# NW Bicester

An application for the exemplar phase of the  
NW Bicester Eco Development proposals submitted by  
P3Eco (Bicester) Limited and the A2Dominion Group

## Environmental Statement Addendum, April 2011

**Figure 3-2 Post-development extent comparison**

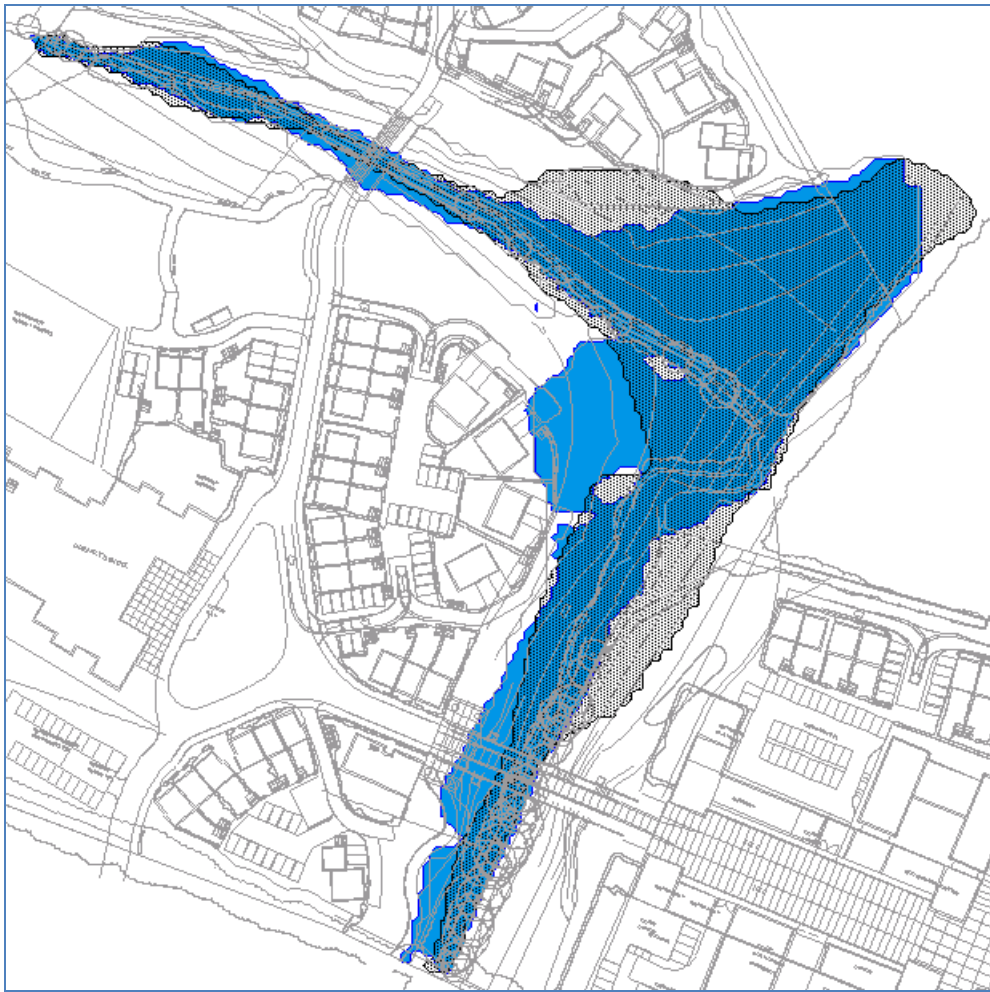
Figure 3-2 shows the change in flood extent caused by the proposed development for the 1000-year flood event (i.e. Flood Zone 2), where the revised baseline is shown in blue and the post-development extent in black.

This shows that around the proposed bridge on the tributary, the contouring and bridge structure have little impact on the modelled flood extents. Downstream of this area, the re-contouring causes additional flooding on the open space on the left bank, but this does not threaten the proposed development. At the confluence with the River Bure, the re-contouring has significantly reduced the flood extent on the western side of the confluence, removing the area of flooding that impacts the gardens and roads from the revised development masterplan. Downstream of this area, the landscaping associated with the second bridge has decreased the flood extent at the bridge location downstream, but increased the flood extent upstream of the bridge on the left bank of the River Bure. This also does not threaten the proposed development.
